SB-10043548-1272

Technical Bulletin

37 12 03 February 24, 2012 **2027120** Supersedes T. B. V371202 dated January 12, 2012 to include a Tip for proper installation of Part No. 5K0 713 933 onto shifter cable.

Transmission Noise When Driving, Possibly from the Differential Area

Figure 1

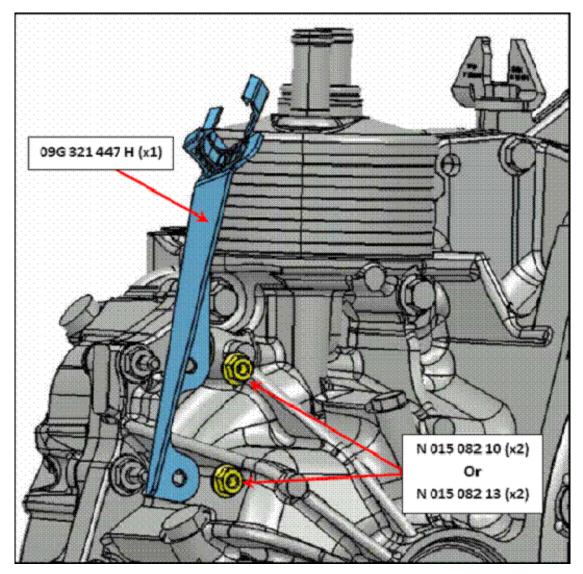
- Disconnect shifter cable from multifunction range switch and from front and rear shifter cable brackets.
- Replace rear shifter cable bracket Part No. 09G 321 447 H (1) and nuts Part No. N 015 082 10 (2) Or Part No. N 015 082 13 (2) as seen in Figure 1.

Figure 2

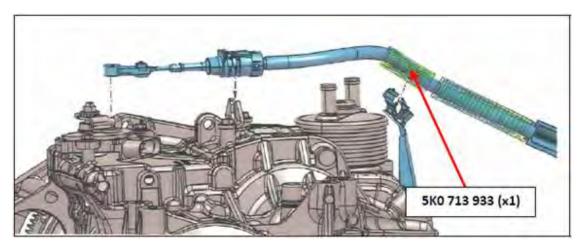
• Install and properly position rubber star hose Part No. 5K0 713 933 (1) onto shifter cable as indicated in figure 2.

Slight trimming or movement of existing cable shielding may be necessary to properly install rubber star hose Part No. 5K0 713 933 onto shifter cable (figure 2).

Figure 3

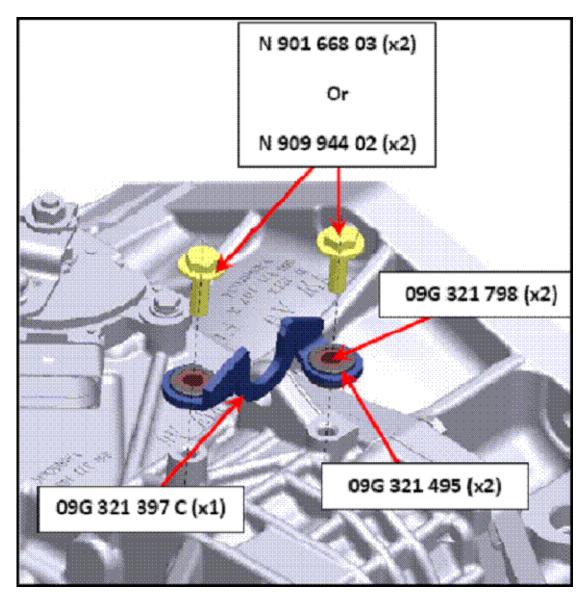
• Install front shifter cable bracket Part No. 09G 321 397 C (1), grommets 09G 321 798 (2), sleeves 09G 321 495 (2) and bolts Part No. N 901 668 03 (2) **Or** Part No. N 909 944 02 as indicated in figure 3.

Figure 4

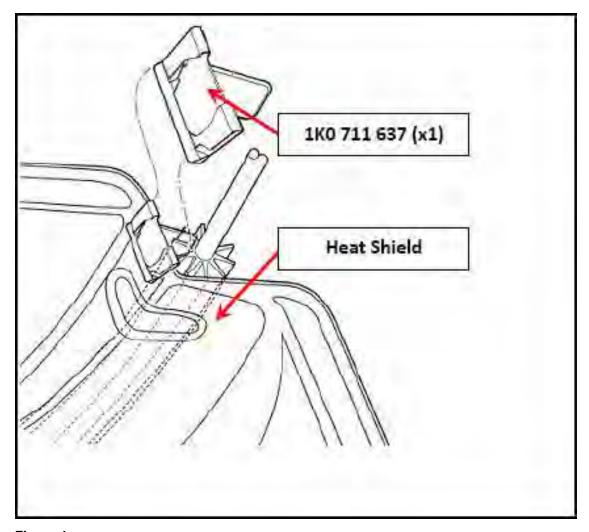
- Raise and support vehicle.
- Install shifter cable retaining clip Part No. 1K0 711 637 (1) onto existing heat shield (Figure 4, 5 and 6).

Care must be taken not to distort or damage heat shield. Shifter cable retaining clip used to secure shifter cable to heat shield and restrict shifter cable movement.

Figure 7

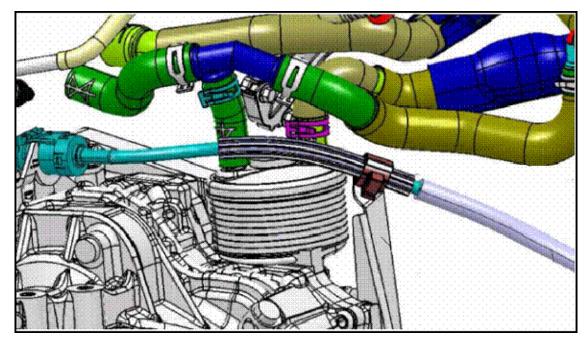
• Reattach shifter cable to multifunction range switch, front bracket and rear bracket, making sure star hose is securely fitted and clamped into rear bracket (Figure 7).
